Rezoning Transportation Analysis

Petition Number: 2019-071

Date	Description
07-19-2019	First Review

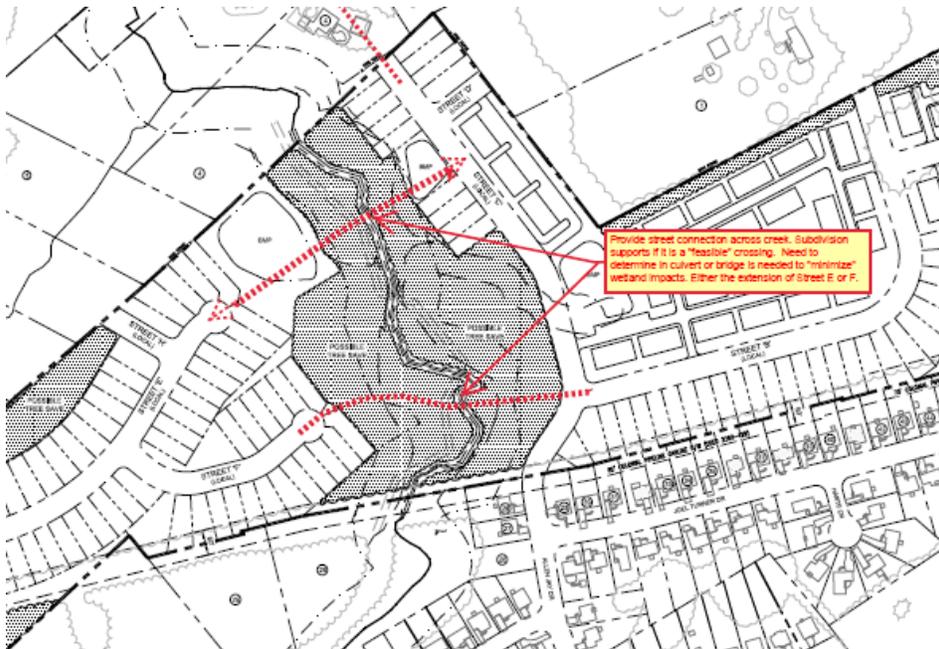
8. The petitioner should revise the site plan and conditional note(s) to provide a local street connection across the stream dividing the property, which will provide a continuous (not direct) vehicle, pedestrian, and bike route between Sunset Rd. and Oakdale Rd. through the subdivision. This proposed street connection needs minimize wetland impacts. This street connection is required by the City's Subdivision Ordinance (Chapter 20) see options below.
